TECH TIPS #44

JANUARY 1996

DIPSTICK COMMONIZATION - FX/XL

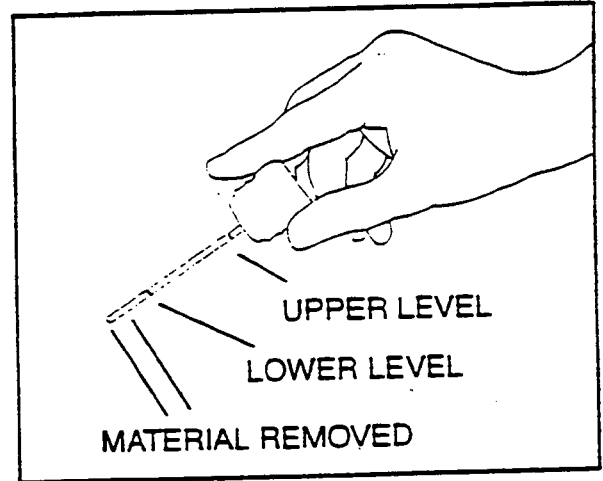
An upcoming production change will be the commonization of oil tank dipsticks between Sportster and Softail models.

Shortening the dipstick will allow it to fit in both model's oil tanks. The location of the lower level mark is the same. The upper fill mark, which Softails previously didn't have, is applicable to all dels.

The new part number, 62634-84A, retrofits to Softail models - 1984 and later and Sportster models - 1982 and later.

NEW REFLECTORS

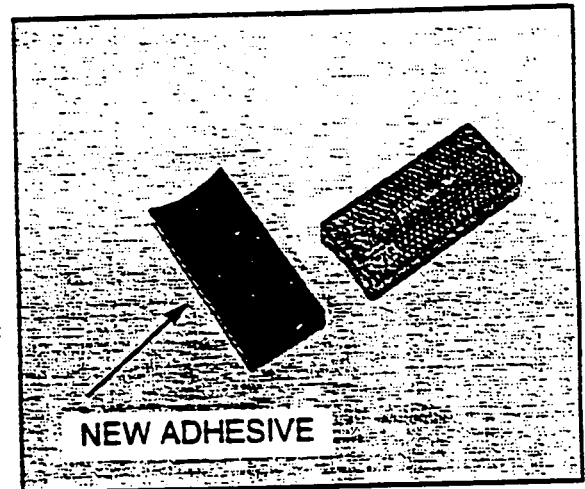
The adhesive material used to retain the front frame reflectors has been changed on all models. The improved adhesive will change the color of the adhesive material from white to black. This will also eliminate the cable straps which technicians had to remove during predelivery and set-up.

XL SPORT FORK HEIGHT

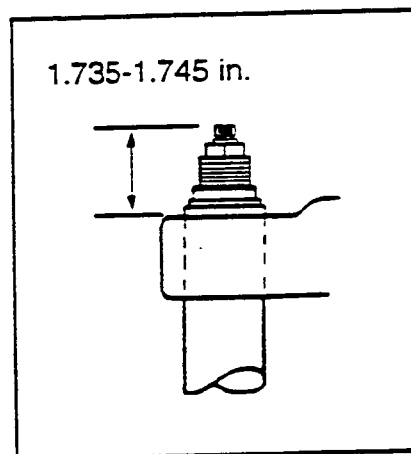
The 1996 Predelivery & Set-up Manual indicates the fork tube height for XL Sport model is 0.735-0.745 in., it should be 1.735-1.745 in. (44.1-44.3mm) with the adjuster knob fully bottomed. Please make note of this.

CLUTCH RELEASE RAMP CHANGE

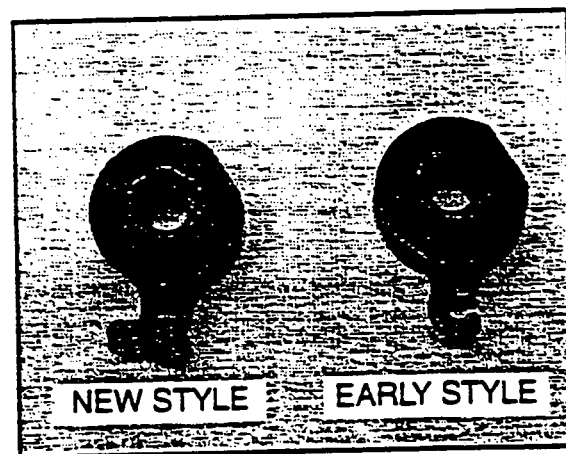
Beginning with vehicles built in early January, the outer clutch release ramp has been changed. The new ramp, part number 25409-94A, has the coupler on the inside of the ramp. The clutch adjustment procedure and lever freeplay remain the same. The change was made to prevent any possible contact between the coupler and primary cover.
